SUBJECT: WILLOW CREEK SECTION E

This form must be completed and submitted with all drainage plans
 Project WILLOW CREEK SEC E Detention Facility Design Return Period 25 yrs.

LETTER OF INSUFFICIENCY
OF DRAINAGE PLAN

RE: Willow Creek Section E

TOP OF DAM EL. 425.00 FT.
TOP OF SPILLWAY EL. 424.5 FT.
0.366 ACRE-FT. @ EL. 425.00 FT.
0.290 ACRE-FT. @ EL. 424.50 FT.
INVERT OF PIPE EL. 421.00 FT.
MINIMUM DEPTH OF 4 FT IN MIN STORM EVENT

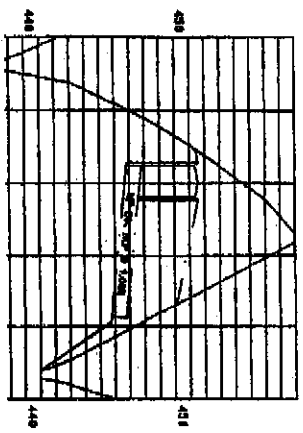
For example: the proposed pond on Lot 110 will back water up to an elevation of 425 feet, rendering the lot unbuildable with its existing contours.

You must show the exact construction details of the pond then add the maintenance easement around the pond before determining the lot size required to house the pond plus a house.
